Service Bulletin No: 53-008

ATA Chapter: 53

FUSELAGE - GENERAL**DO A CHECK OF THE MATERIAL SPECIFICATION USED IN THE MANUFACTURE OF THE ENGINE MOUNT FITTINGS AND, IF NECESSARY, DO A CHECK FOR CRACKS WITH A BOROSCOPE****1. Planning Information****A. Effectivity**

PC-7 aircraft MSN 101 thru MSN 618.

Check of the Material Specification
Figure 1

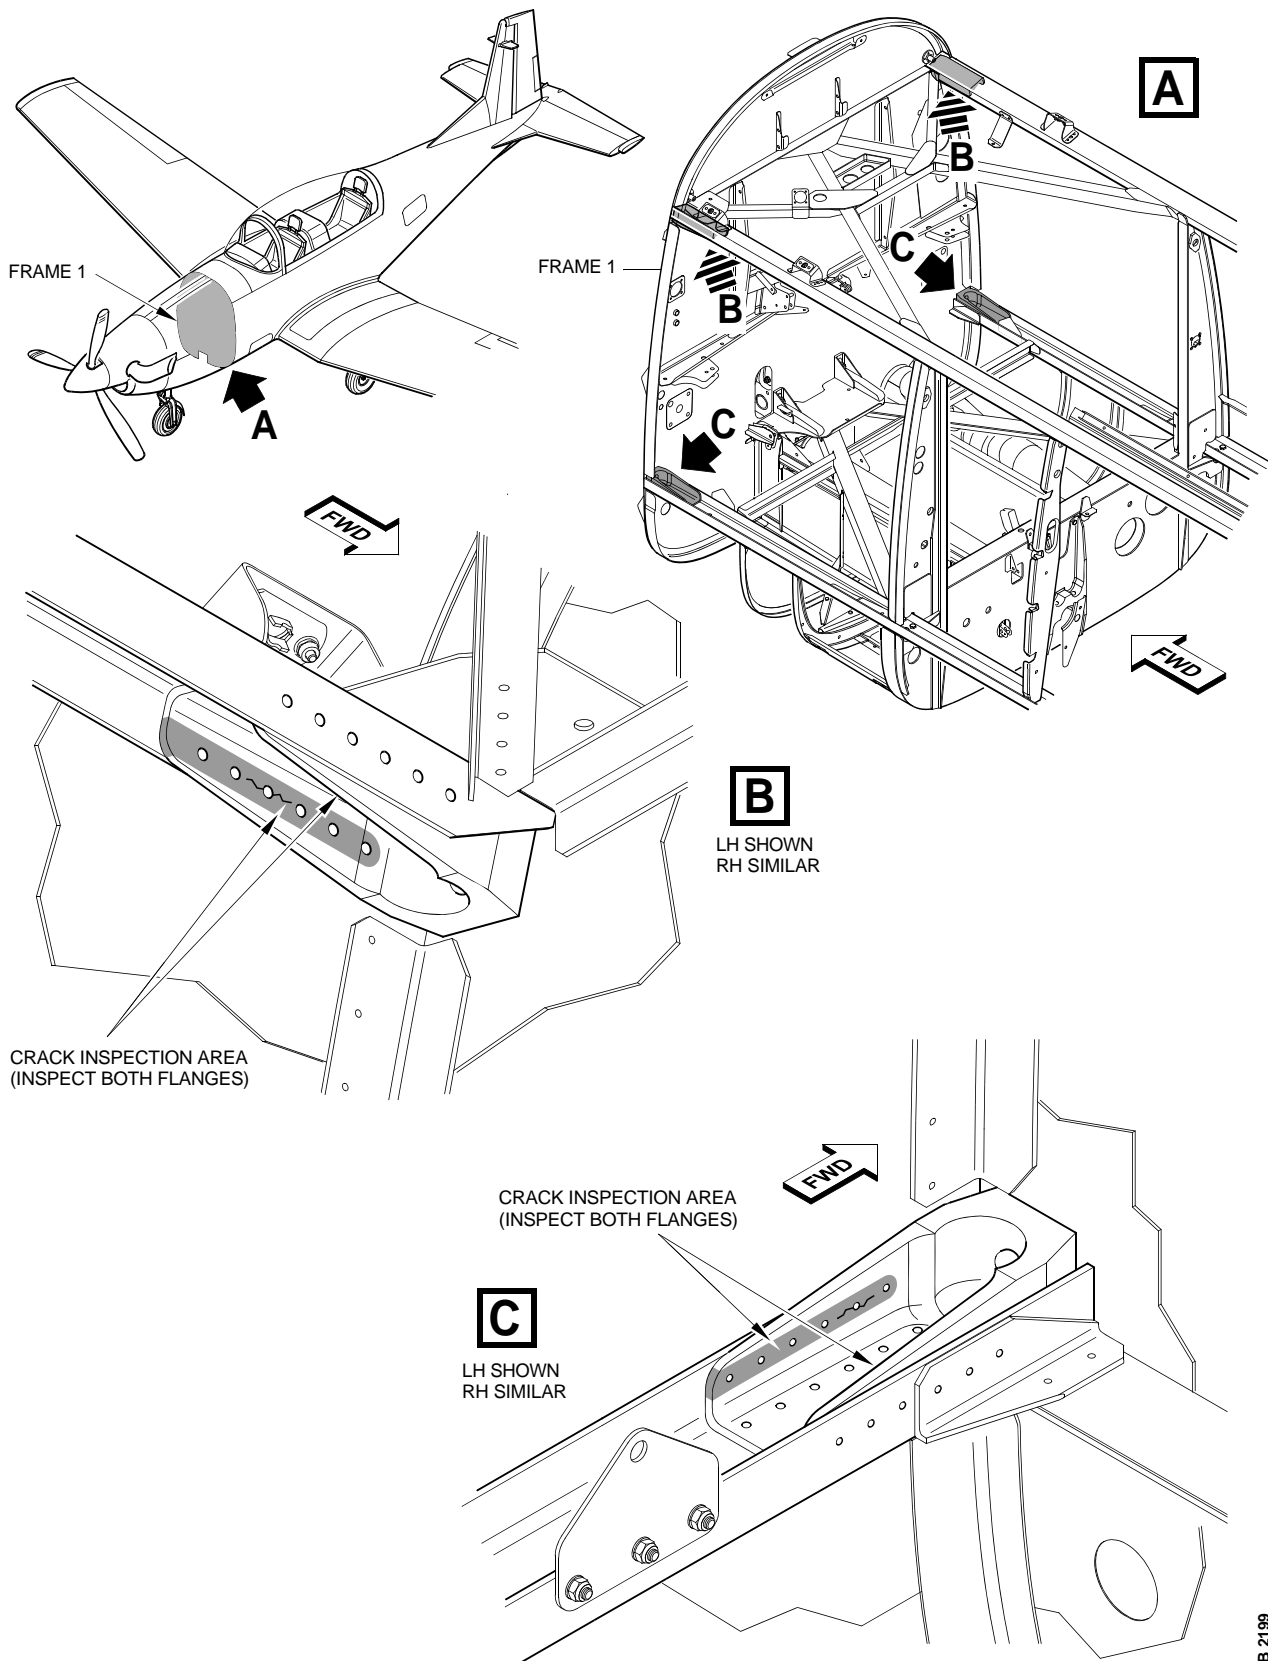
B. Do the Test to Find the Material Specification (Ref. Fig. 1)

- (b) Put the eddy current probe in position on the left upper engine-mount attachment-fitting (1) (P/N 112.35.07.152).
- (c) Record the value shown on the test equipment.
- (d) Compare the value recorded above with the values recorded in Section 3.A.(5) and determine if the attachment fitting is manufactured from AA2024-T351 or AA2124-T851.
- (e) Do Steps 3.B(1)(b) thru (d) again to make sure the result is the same.

Fittings - Crack Inspection (If Necessary)
Figure 2

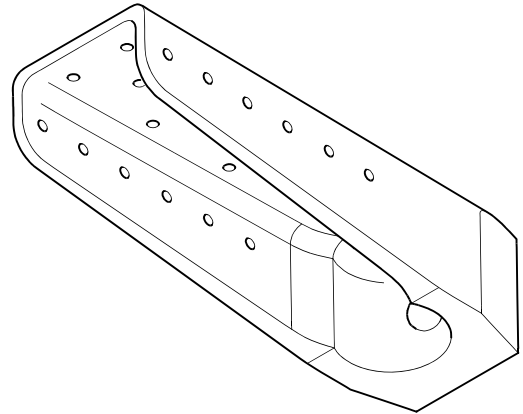
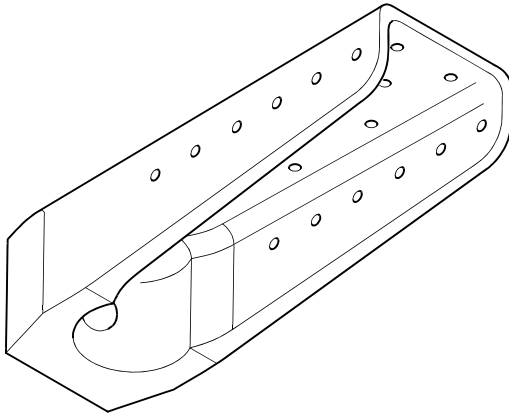
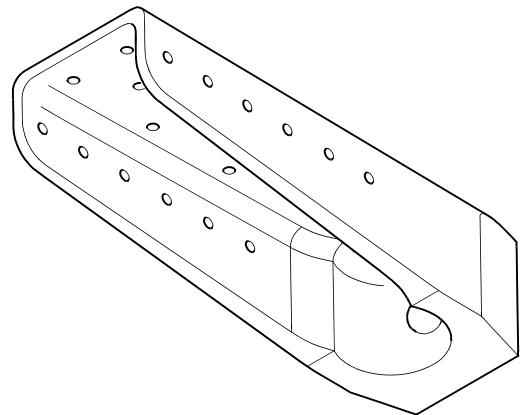
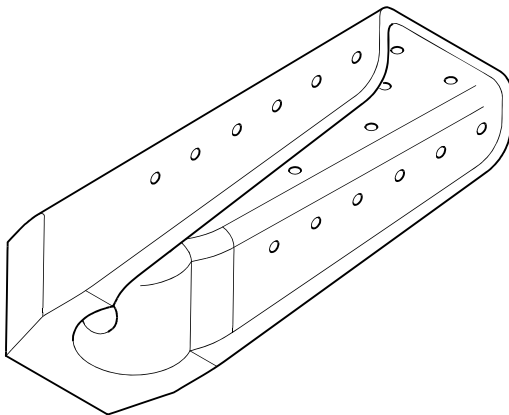
C. Do the Boroscope Inspection to Find Cracks (Ref. Fig. 2)

- (1) Obey the manufacturer's instructions and use a boroscope to examine the areas shown in Fig. 2:
 - (a) Use the aluminium or steel tube as a guide for the boroscope to access the inspection areas.
 - (b) If you find cracks:
 - 1 You must contact Pilatus Customer Support before next flight. The address is:
